DEVELOPMENT DETERMINATION PANEL MEETING

WEDNESDAY 10 APRIL 2024

3.1	DA2023/1230 - 161 B and 163 Seaforth Crescent SEAFORTH - Demolition works and construction of a dwelling house including swimming pool and associated works	3

DEVELOPMENT APPLICATION ASSESSMENT REPORT

Above: The extent of the height of building non-compliance above natural ground level, highlighted in yellow.

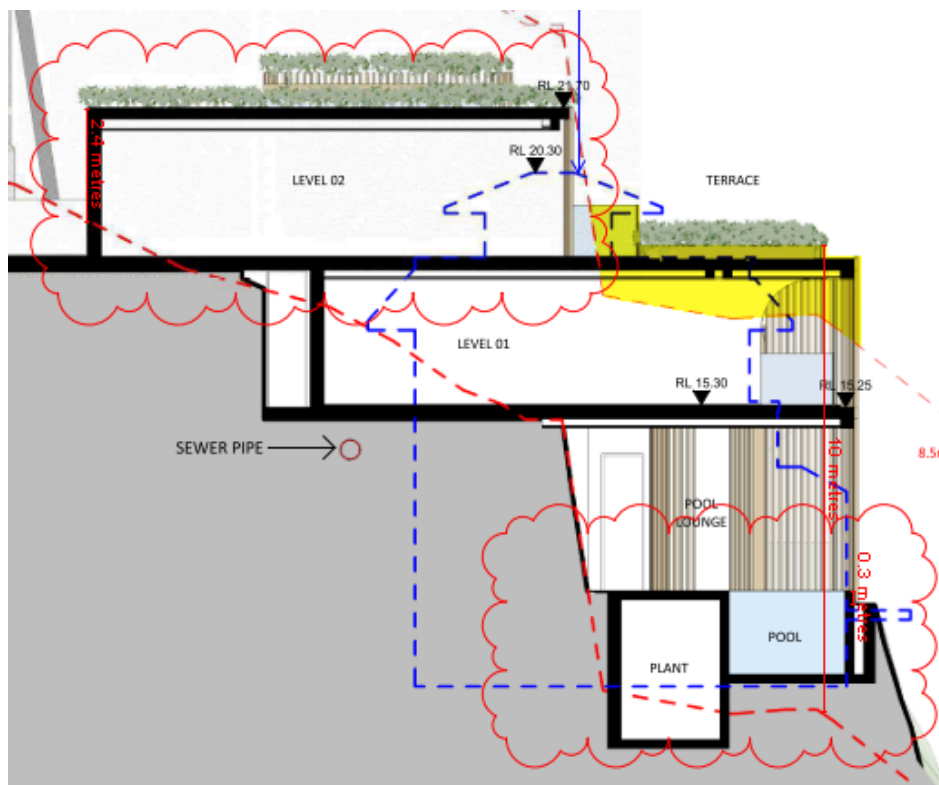
- The proposed development demonstrates a dwelling house logically located on the yet unregistered lot approved under DA0184/2016, in consideration of the applicable built form controls, and
- If the building height was calculated in accordance with *Bettar v Council of the City of Sydney [2014] NSWLEC 1070*, being from the natural ground level, rather than the existing ground level (whether disturbed or undisturbed), the maximum height would be calculated to a maximum of 10 metres (17.64%) and for a smaller portion of the development, as shown below:

Figure 1: Building line of garage floor in relation to the building line of upper floors on adjoining sites.

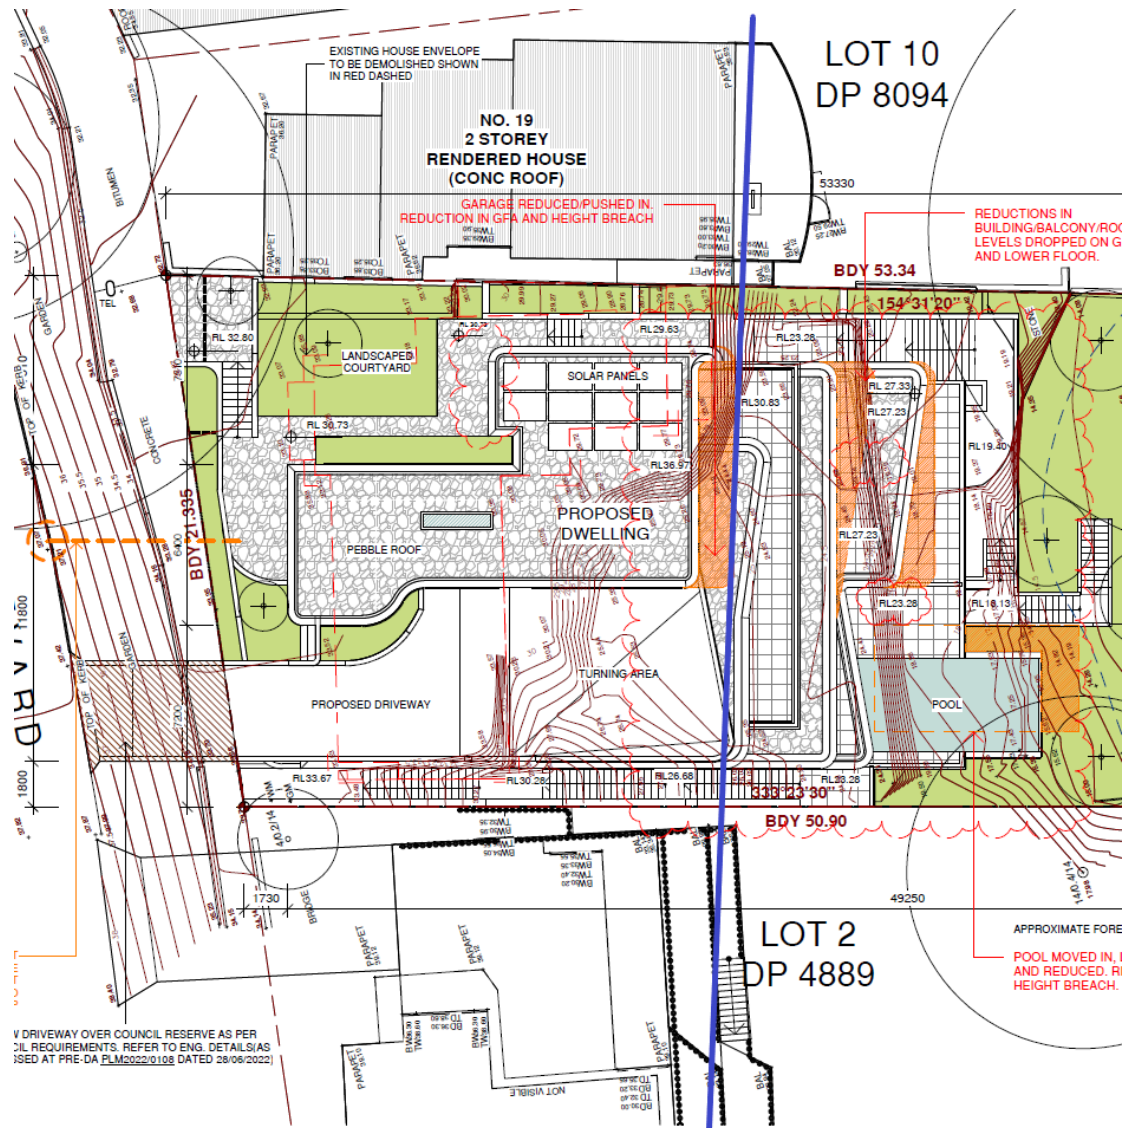
Therefore, Council is satisfied that the applicant's written request has adequately addressed the matters required to be demonstrated by cl 4.6(3).

Figure 1 - Extract of areas breaching the 8.5m height limit in yellow based on the applicant's height plane through long section.

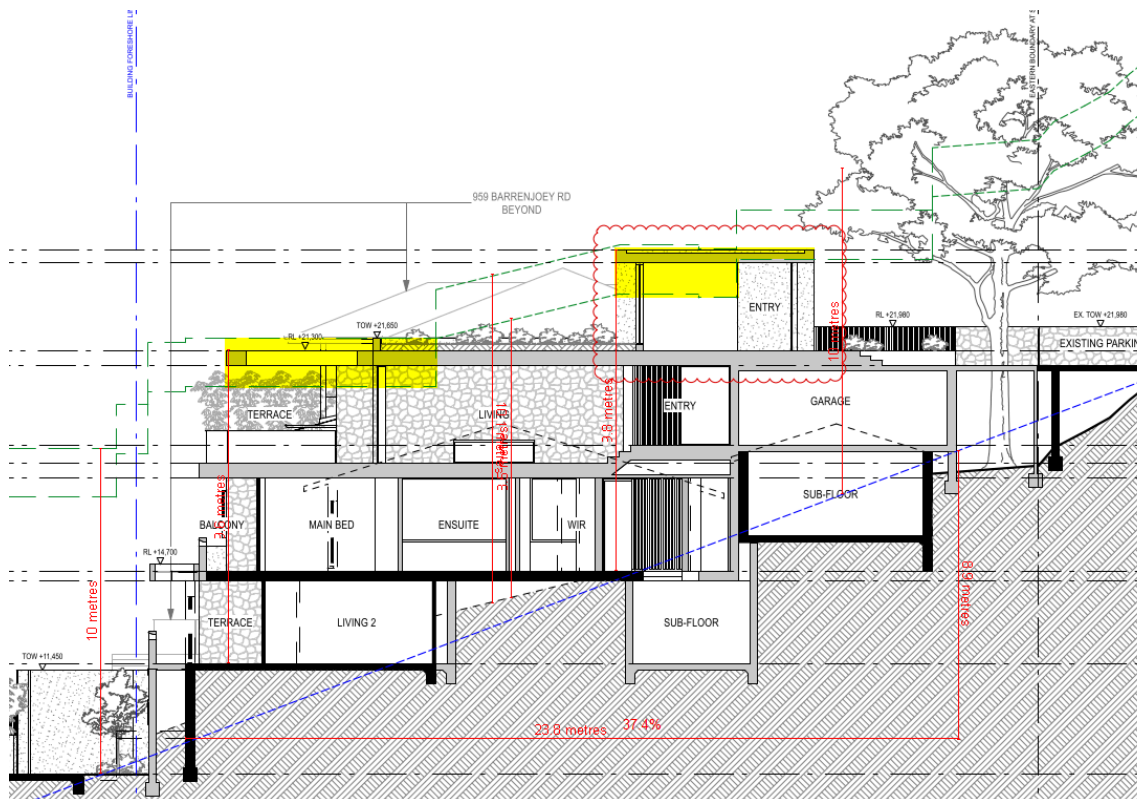
Development standard:	Height of buildings
Requirement:	8.5m
Proposed:	9.8m
Percentage variation to requirement:	15%

The applicant contends that the 10m building height concession pursuant to Clause 4.3(2D) of the LEP should apply to the development and as such, the proposal would not need to address the requirements of Clause 4.6 of the LEP. The applicants section appears to show the building within the 10m height plane.

Figure 2 - Extract of survey overlay identifying existing level at north-western corner.

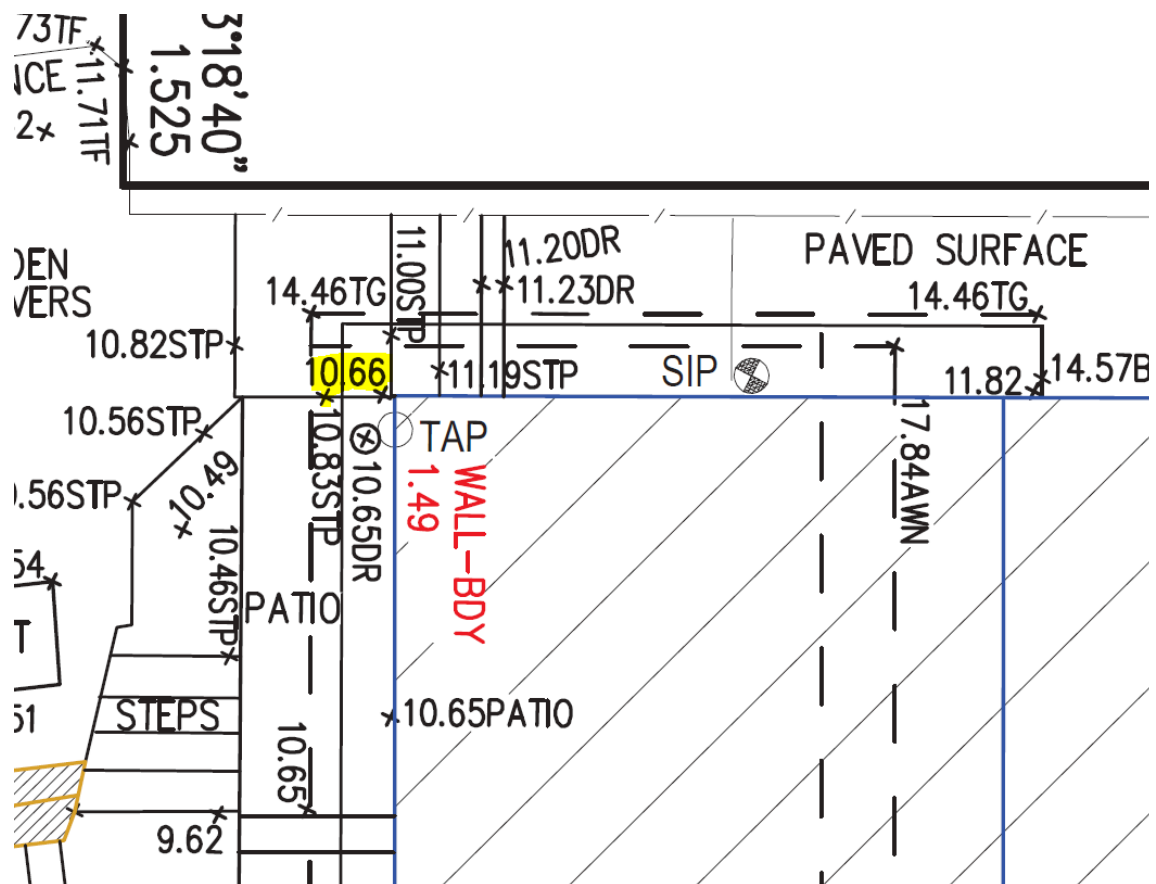
10m height plane. For example, the north-western corner of the proposal sits close to an existing ground level of 10.66 AHD (with the corresponding height of the pergola RL21.300 above) equaling a building height of 10.64m, see extract below in Figure 2. However, there is insufficient information to conclude that the building is up to this height.

Notwithstanding the above, the elements that are between 8.5m and 10m are not considered to be *minor* and in such a way that would qualify for the concession under Clause 4.3(2D). Council is not satisfied that the application has accurately identified the building height from all areas above the existing ground level.

Figure 1 - Southern Side of building - Area marked red non-compliant.

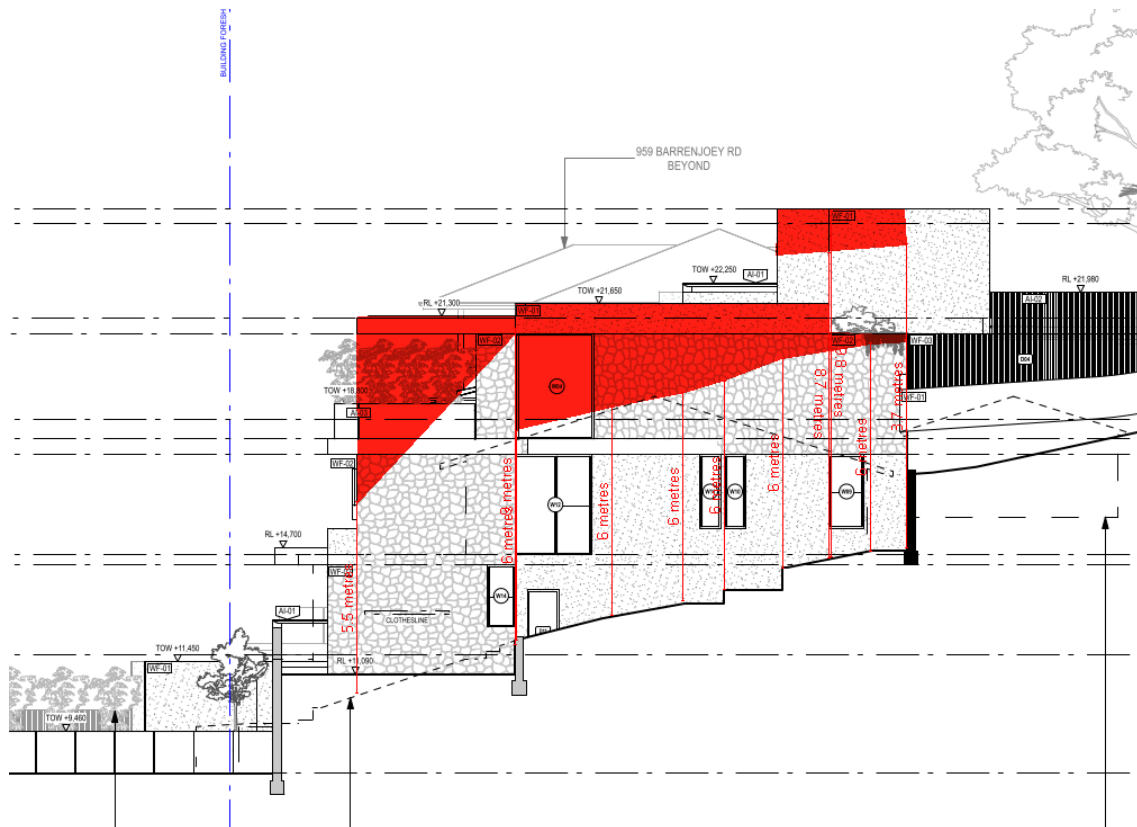
The proposal has an encroachment of the southern side boundary building envelope (Figure 1 below) and the northern side boundary (Figure 2 below).

Figure 1: extent of height breach

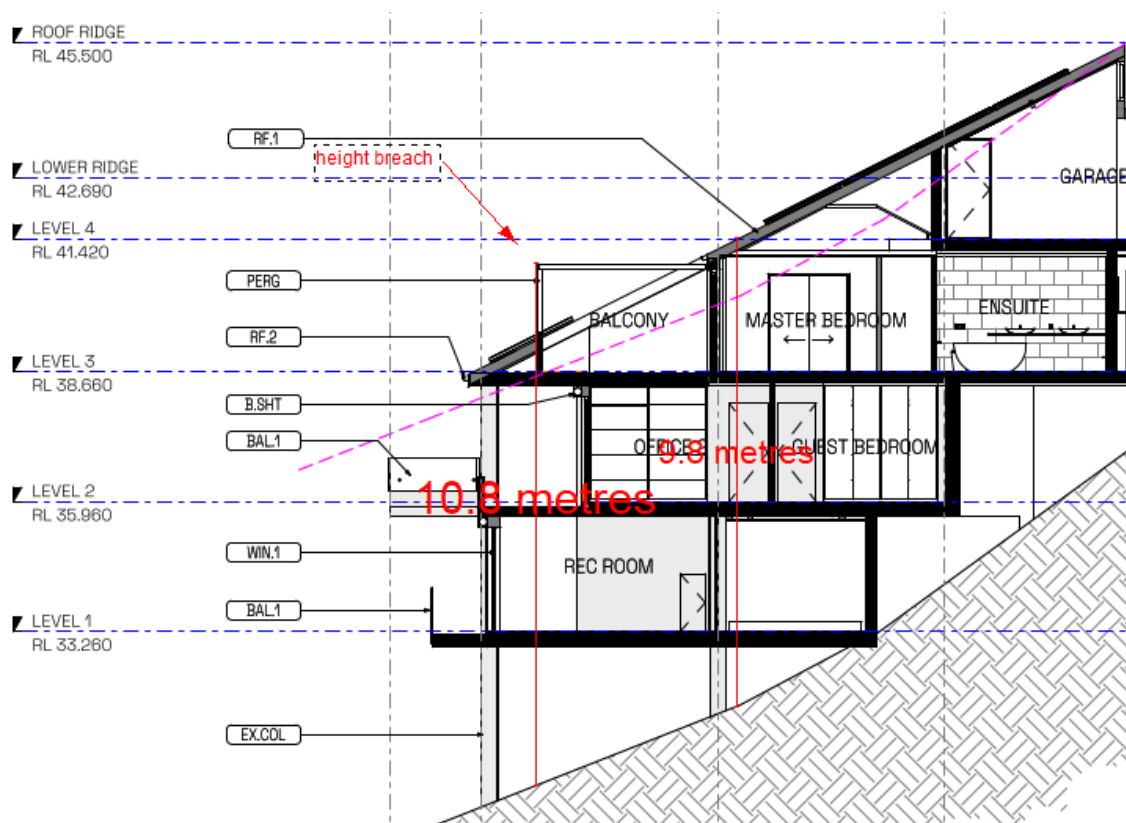
An excerpt from the plans of the non-compliance is shown below:

Figure 1- Envelope non-compliance- Northern Elevation

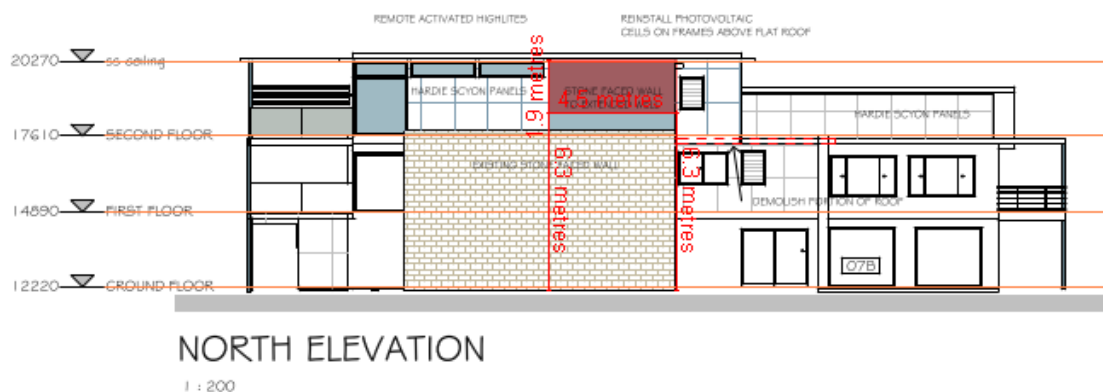
Clause B3 Side Boundary Envelope requires that built structures are sited within an envelope, measured at the side elevations of the dwelling by projecting planes at 45 degrees from a 5 metre height.

In this case, the development proposes a protrusion of the building envelope along the northern side elevation, at a height of 1.9 metres for a length of 4.5 metres, causing a variation of 38% to the control.
